# **Historic Architectural Review Commission**

# **Staff Report for Item 2**

**Application Number:** H2023-0010

Address: 1106 Grinnell Street

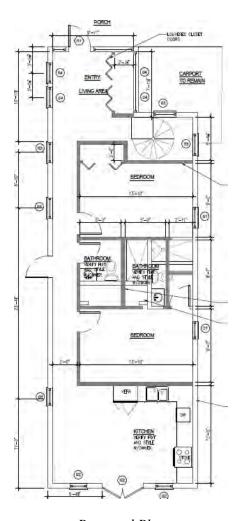
A Certificate of Appropriateness under review is for renovations to a non-historic addition, which includes the reconstruction of the roof, walls, and new fenestration openings. The plans also propose a wood rear deck, less than 30" from grade.

All new construction materials include wooden structural elements, hardiplank for siding, aluminum windows and doors, and 5 v-crimp for roofing finish.

It is the staff's opinion that the proposed design conforms with cited guidelines. As proposed the roof will be the same form as originally built. The new proposed design fits within the character of surrounding single-family homes. The scale, mass and proportions of the new construction are in keeping with similar land use structures within the area and the building elevation changes on the rear will not overshadow the existing historic context.
